MONTGOMERY COUNTY PLANNING DEPARTMENT

MEMORANDUM

REVIEW TYPE: Pre-preliminary Plan of Subdivision (Resubdivision)
APPLYING FOR: Advice on an 8-lot subdivision for 8 one-family detached dwelling units

PROJECT NAME: Dorset Shire II
CASE NO. 720070020
REVIEW BASIS: Chapter 50, the Subdivision Regulations and Chapter 59, the Zoning Ordinance

Attachment B

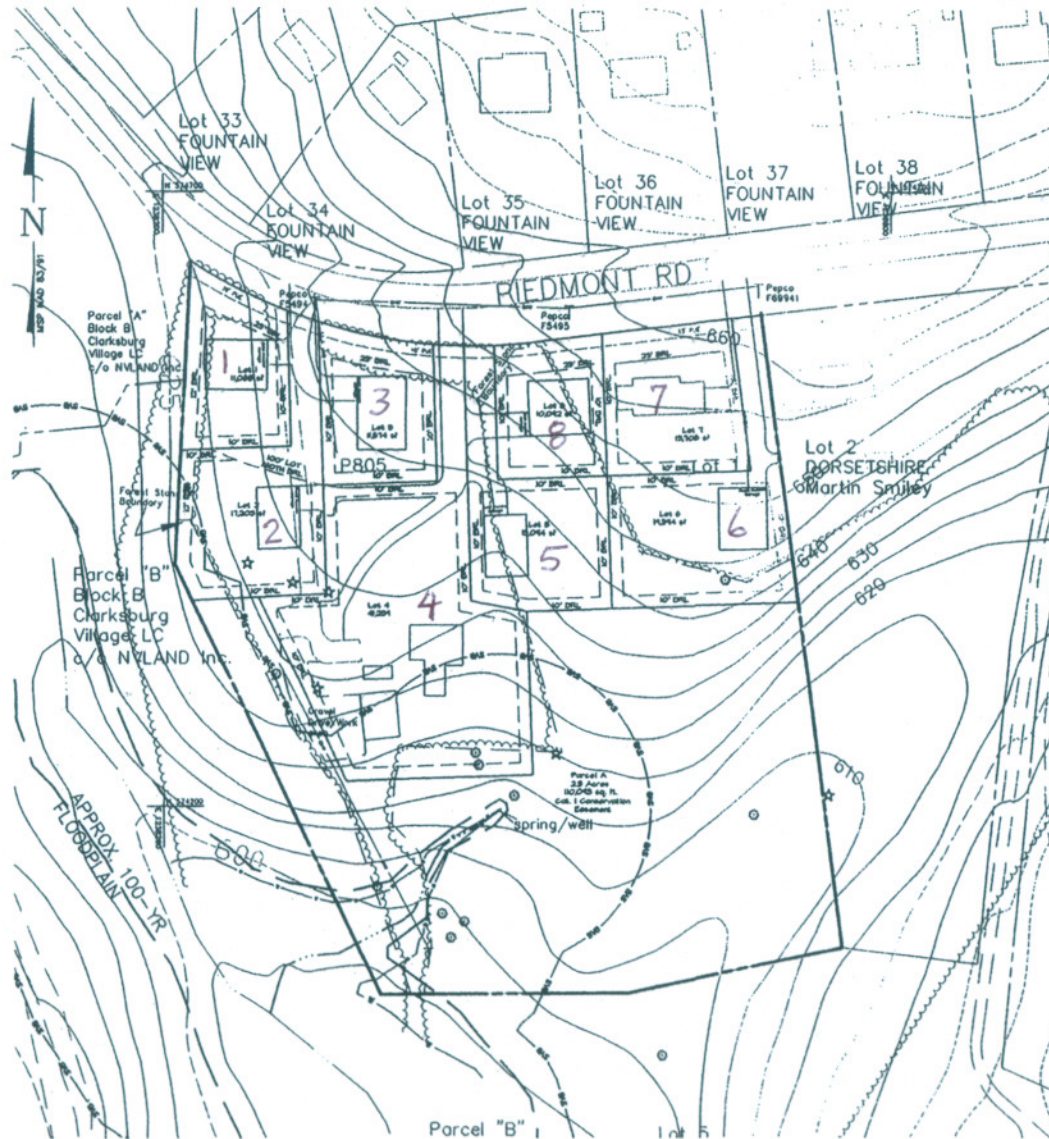
The proposed development introduces the use of small scale, pipestem lots along Piedmont Road. Currently, the only pipestem lots along the street are the two larger lots in the adjacent Dorset Shire subdivision. An original 9-lot version of the pre-preliminary plan included creation of an internal public street that avoided the use of pipestems (Attachment E), but the applicant is no longer considering that option based on comments from staff that

at least two lots would have to be dropped to justify use of the cluster option of development. The applicant believes the proposed 8-lot configuration, and the use of pipestem lots, is compatible with adjacent development. In staff's opinion, use of pipestems may be appropriate because they reduce the overall development envelope, but the cluster of four lots on the eastern half of the subdivision should be reduced by one. In development Option A (Attachment B), the orientation of proposed lot 5 results in a relationship between houses on proposed lots 4, 5 and 8 that is too tight. In addition, proposed lots 6 and 7 result in a two to one relationship next to existing lot 2 in the adjacent subdivision. Development Option B (Attachment C) improves the internal relationship between lots, but also places two houses next to the adjacent lot. Staff favors development option B with the deletion of proposed lot 8.
